CENTENNIAL HALL BALLROOM RENOVATION Contract No. BE22-204

ADDENDUM NO.: TWO

DATE ADDENDUM ISSUED: July 14, 2022

A501

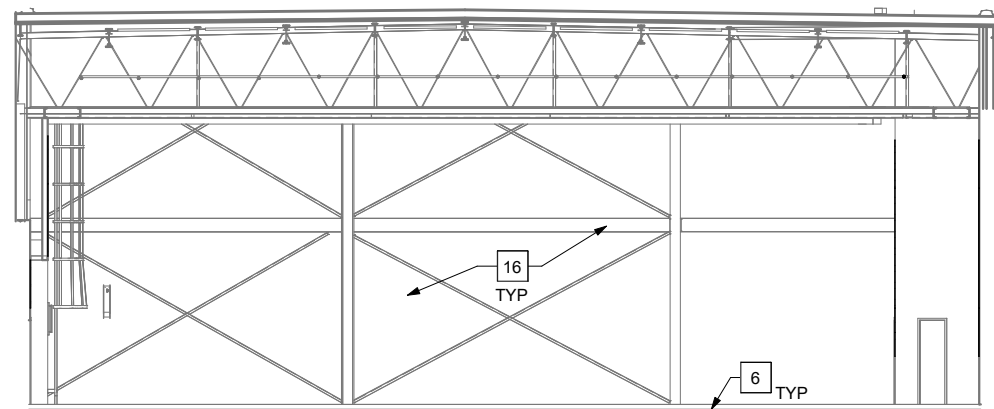
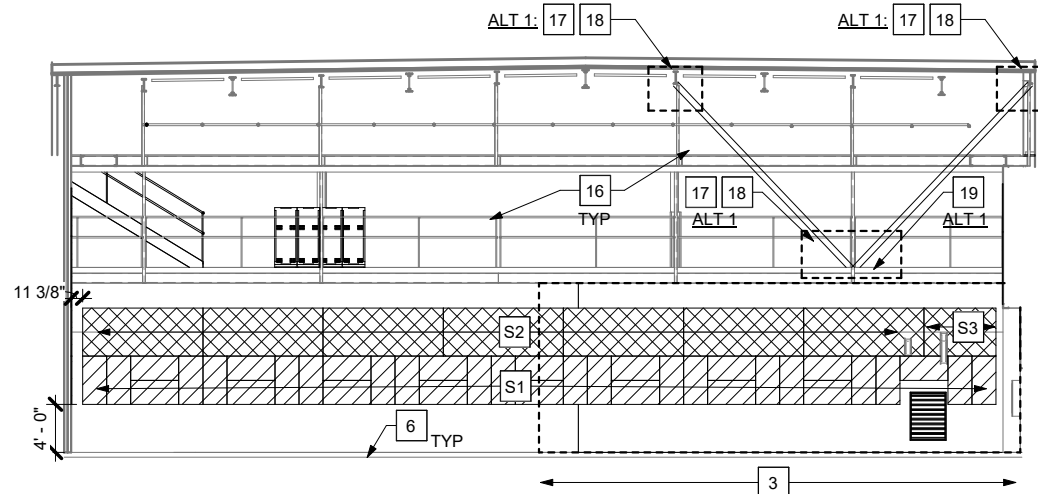
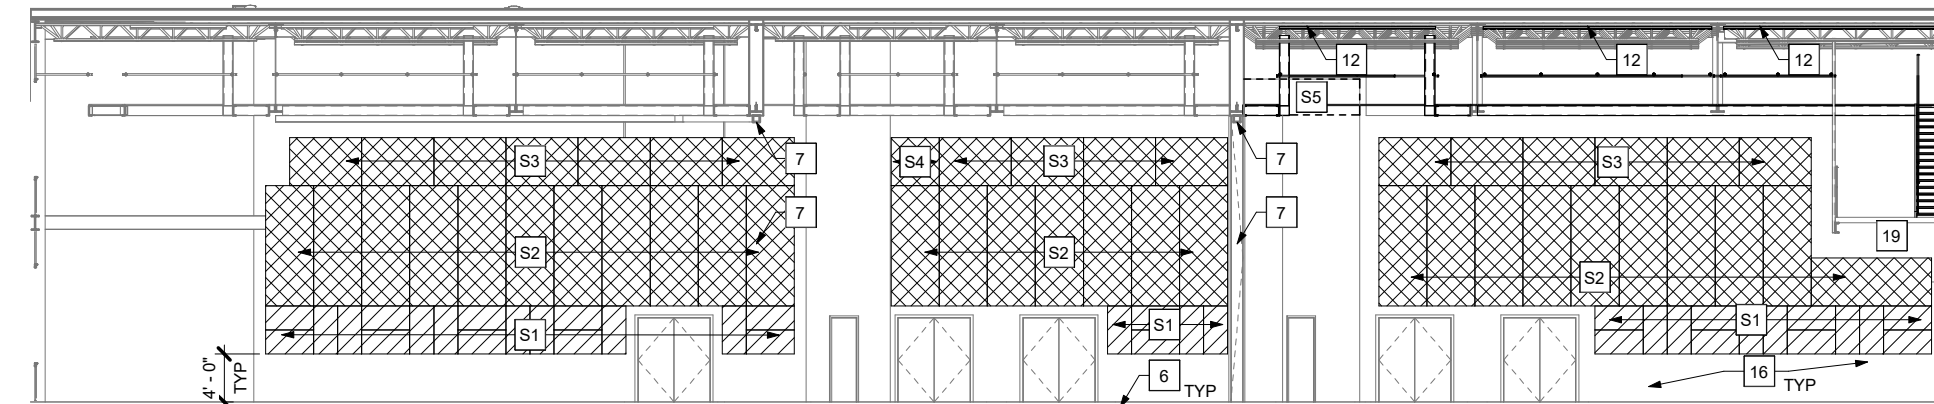
Question: "What framing rework will be needed per sheet note S1/AD222?"

- Item No. 5 Sheet A501. **Replace** the sheet with the attached sheet, labeled Addendum 2.
- Item No. 6 Sheet A802, Detail 6. **Add** the following note with a leader pointing to the wall framing under the sill that reads: "Metal stud framing at 16" o.c. Match framing depth of adjacent wall."

Response: See Drawing Item No. 5 of this Addendum.

A804

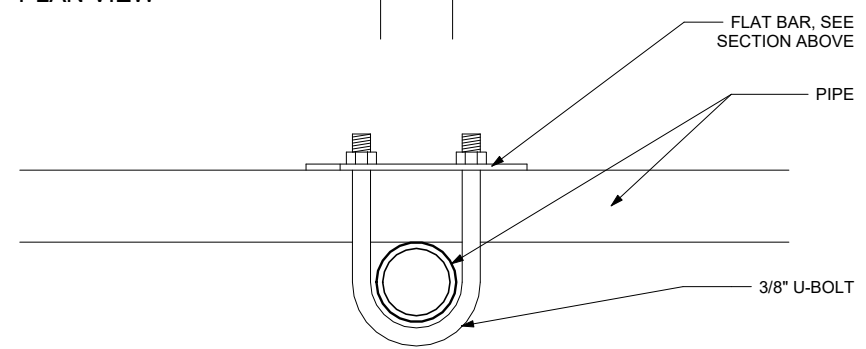
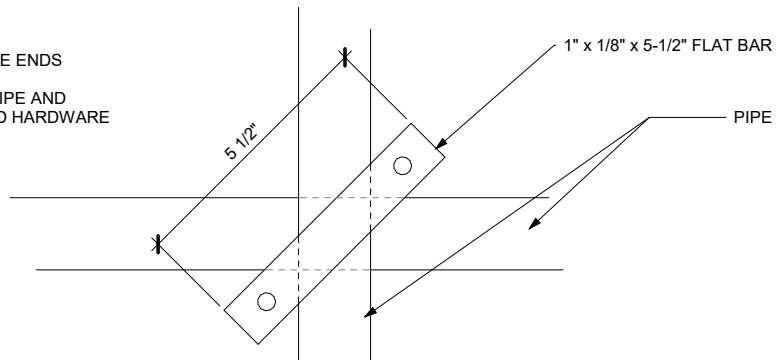
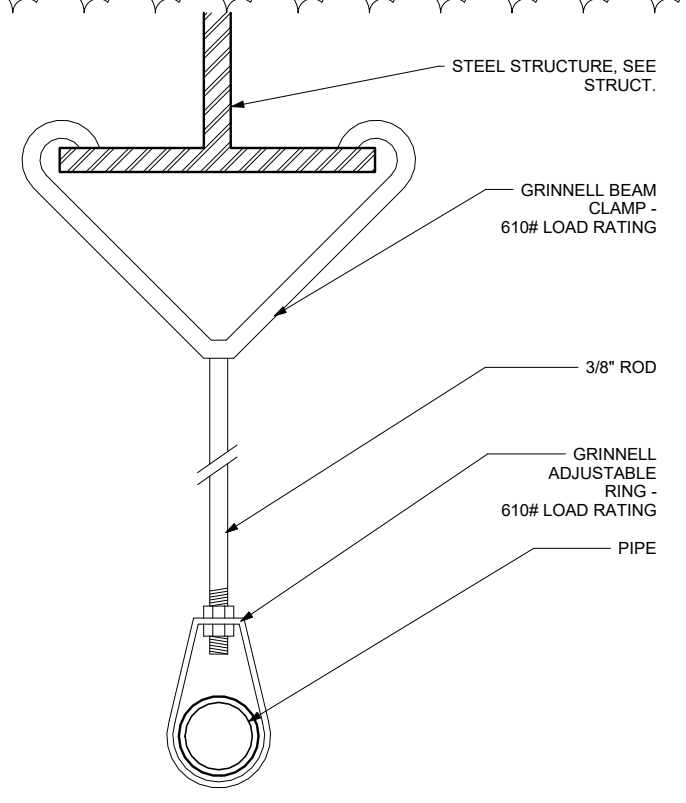
- Item No. 7 Sheet A803. **Delete** the detail 2/A803 "Catwalk Detail".
Modify all references to the detail to read, "1/A804".
- Item No. 8 Sheet A804. **Add** the attached sheet, labeled Addendum 2.

E222

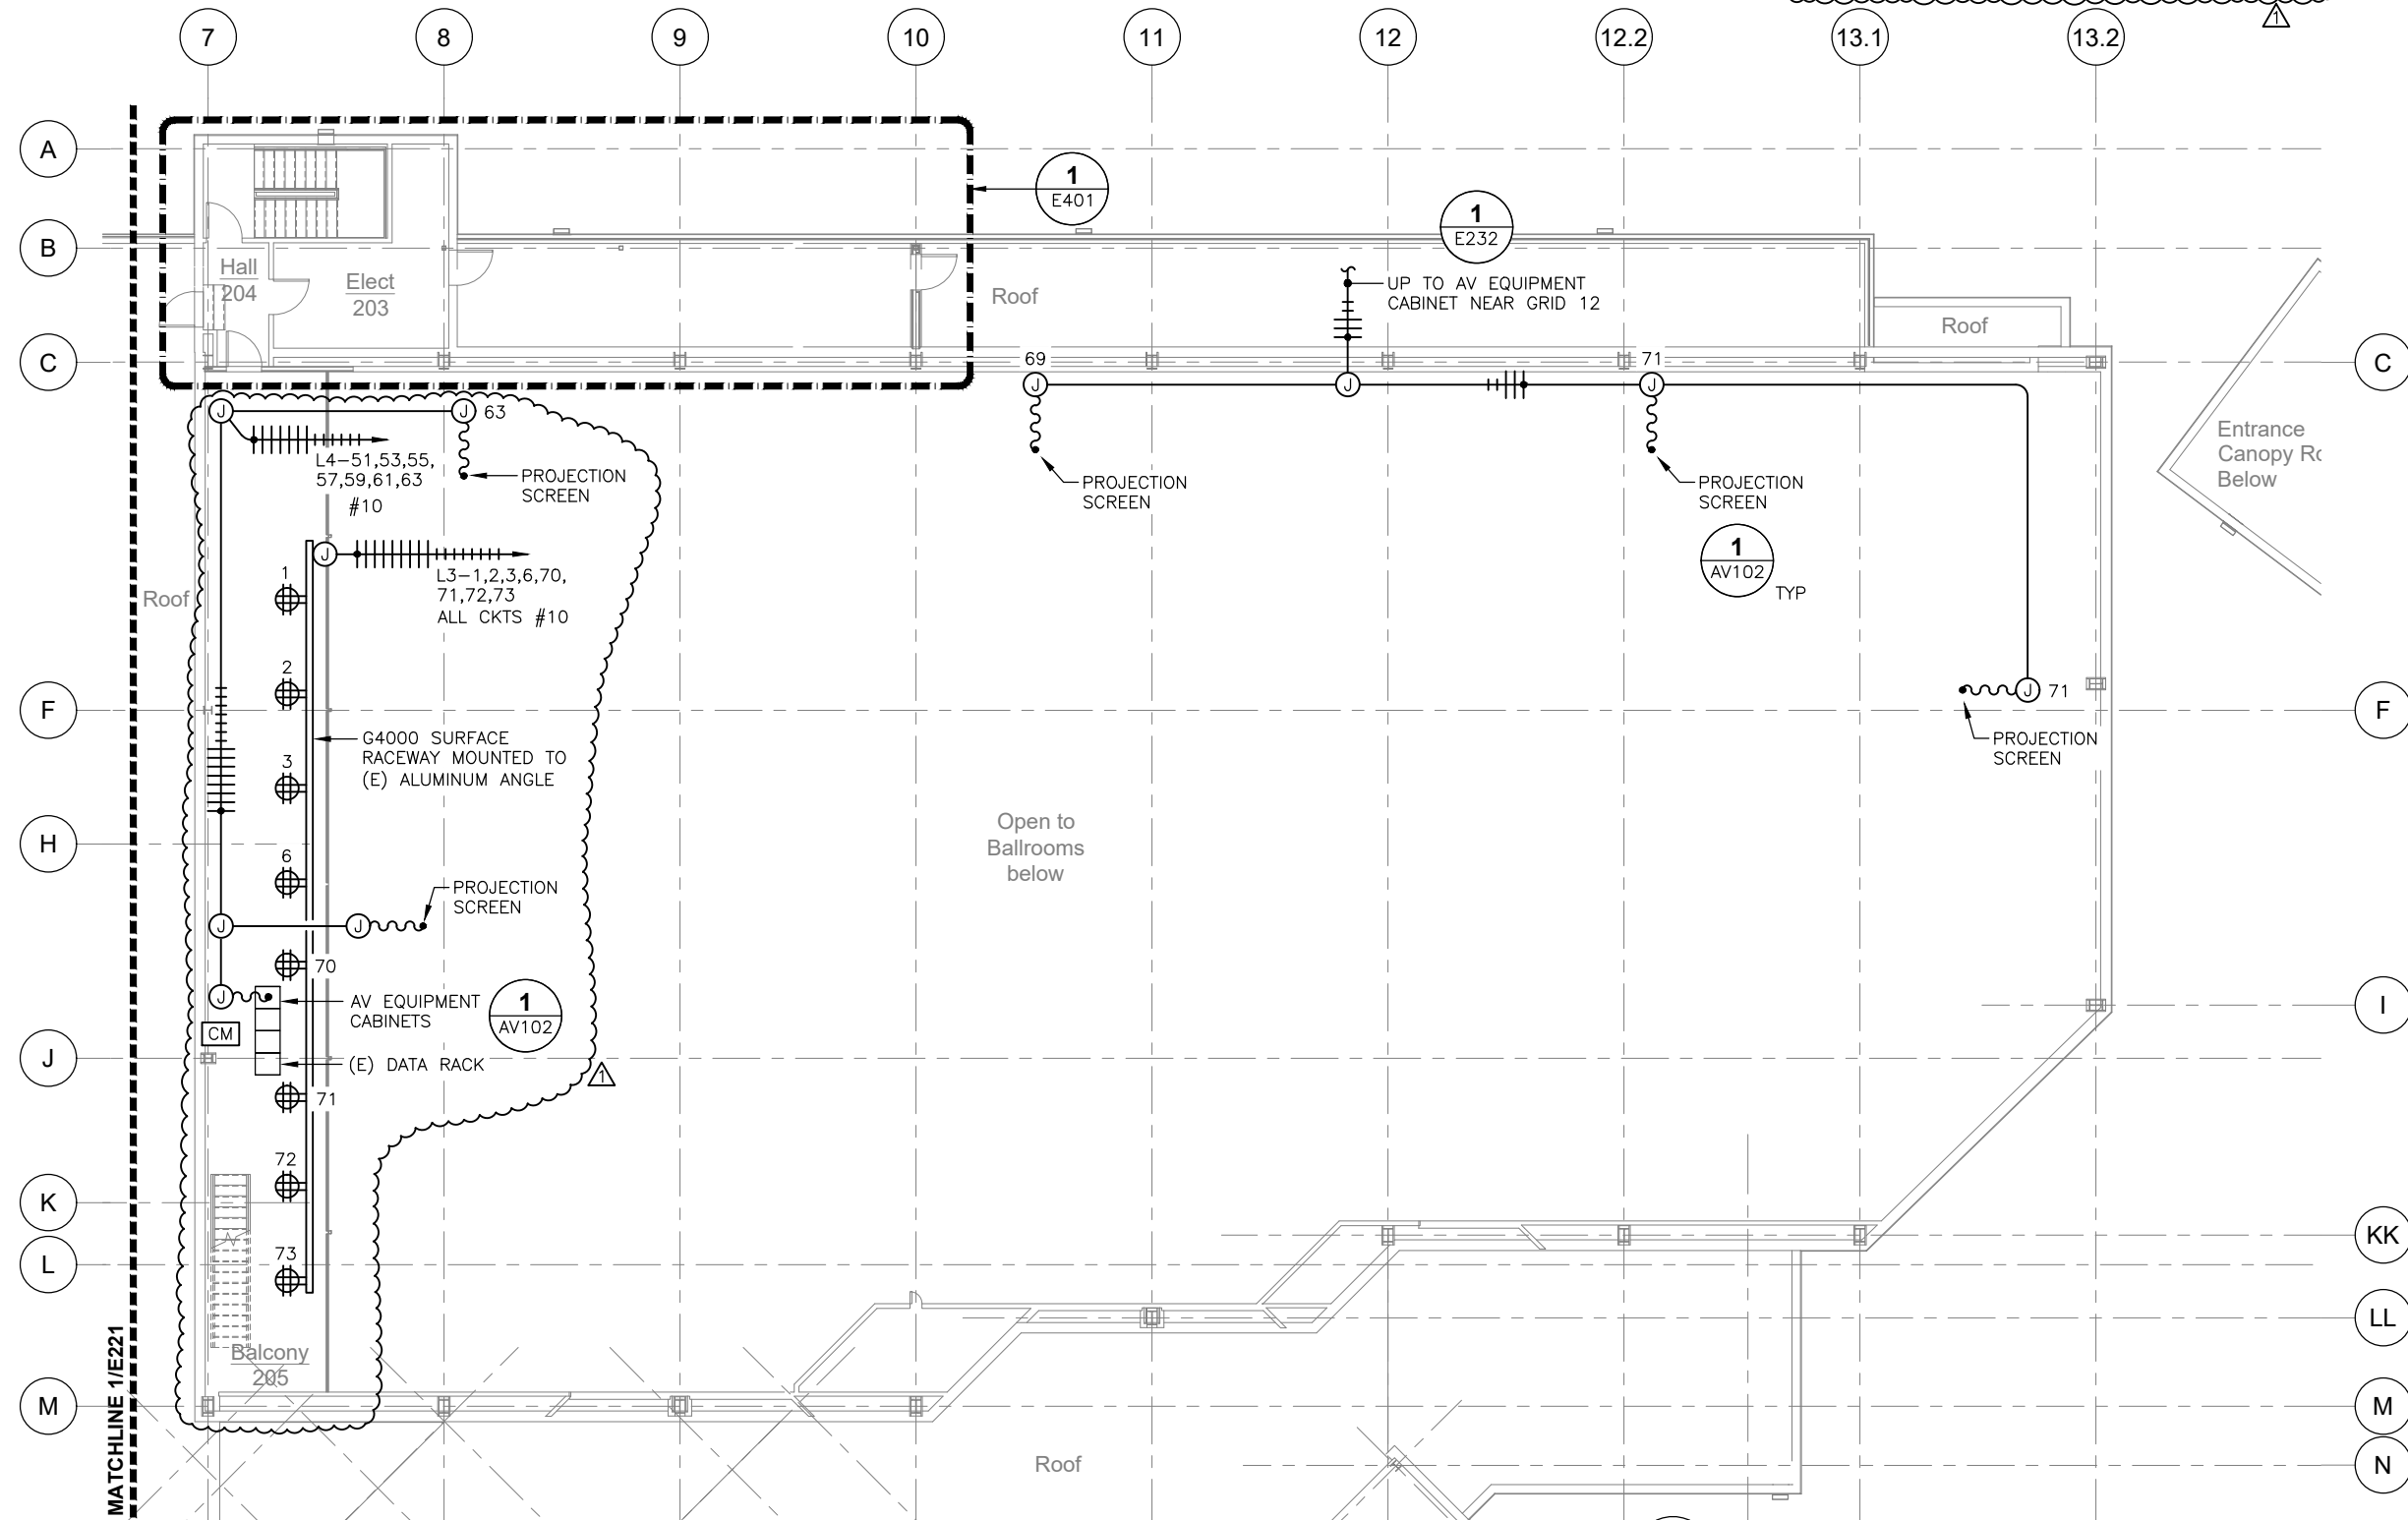
- Item No. 9 Sheets AV601 and 1/AV702: Integrate sound system mute functionality from a dry contact provided by the fire alarm contractor. This includes termination of conductors at the A/V system installed by the fire alarm contractor from the fire alarm control panel. Termination shall be at an unused GPIO connection to Audio DSP shown on AV601 and 1/AV702.

NOTES:
 1. THE FIRE ALARM CONTROL MODULE IN BALCONY 205 SHALL PROVIDE AN INPUT TO MUTE THE AV SYSTEM UPON A FIRE ALARM.
